Access Compliance Report

Public Rights-of-Way

(Curb Ramps)

Intersection ID: 21549	Main Street: S_TRYON_ST	Cross Street: SANDY_PORTER_RD	Location: E
ADA ID: 1DB719E54D6C	Ramp Type: Perp	Initial Pass/Fail: Fail	Overall Compliance: No
			Severity Score: 13.75

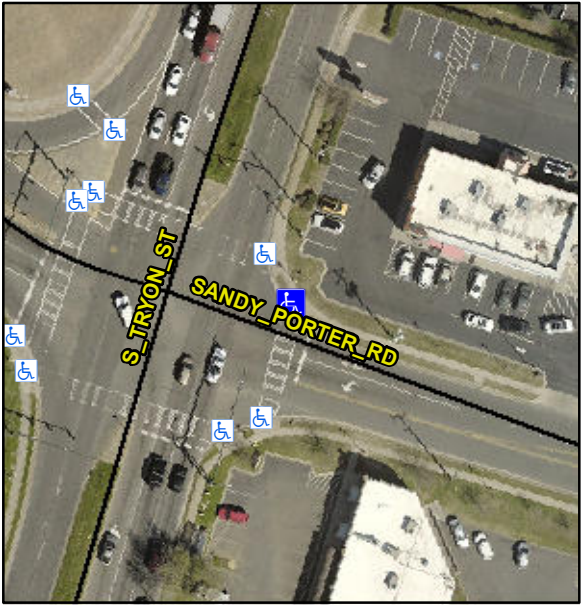
Codes/Mitigation Info/Possible Solution		Field Measurements/Component Compliance			
	Possible Solutions:				
	Remove & Replace Entire Ramp.				
	Surveyor Notes:				
	N/A				
	PROW/ADA:				
	Not Found, R304.2.2, R304.5.3				
Street 1 Name	SANDY PORTER RD				
Stop Condition-Street 2	Signal				
Street 2 Name	N/A				
Stop Condition-Street 1	N/A				
Total Cost:		\$	1850.00

Compliance	Description	Data	Compliance	Description	Data
N/A	Ramp Length (in)	47.0	No	Ramp Slope (%)	10.2
Yes	Ramp Width (in)	48.0	No	Ramp XSlope (%)	2.4
N/A	Flare Type LT	N/A	N/A	Flare Type RT	N/A
N/A	Flare Slope LT (%)	N/A	N/A	Flare Slope RT (%)	N/A
N/A	Flare Traversable LT?	N/A	N/A	Flare Traversable RT?	N/A
N/A	Landing Length (in)	N/A	N/A	DWS Provided?	N/A
N/A	Landing Width (in)	N/A	N/A	DWS Contrast?	N/A
N/A	Landing Slope (%)	N/A	N/A	DWS Length (in)	N/A
N/A	Landing X Slope (%)	N/A	N/A	DWS Full Width?	N/A
N/A	Landing Curb? (Y/N)	N/A	N/A	DWS Offset (in)	N/A
N/A	Shared Landing?	N/A			
N/A	Gutter Ponding?	N/A	N/A	Gutter Slope (%)	N/A
N/A	Gutter Lip Ht (in)	N/A	N/A	Gutter X Slope (%)	N/A
N/A	Painted X Walk1?	Yes	N/A	Painted X Walk2?	N/A
	X Walk 1 Direction	To S		X Walk 2 Direction	N/A
N/A	X Walk 1 Width (in)	112.0	N/A	X Walk 2 Width (in)	N/A
	X Walk 1 Slope (%)	1.4		X Walk 2 Slope (%)	N/A
	X Walk 1 X Slope (%)	2.2		X Walk 2 X Slope (%)	N/A

N/A	Ramp inside XWalk1?	Yes	N/A	Ramp inside XWalk2?	N/A
	Road Slope (%)	N/A	N/A	Clear Space?	N/A
	Road X Slope (%)	N/A	N/A	Clear Space to XWalk (in)	N/A
N/A	Any Obstructions?	N/A	N/A	Storm Grate/Utility Hazard?	N/A
	Obstruction Type			Storm Grate/Utility Type	
		N/A			N/A
			Yes	Surface Condition? (G/P)	Good
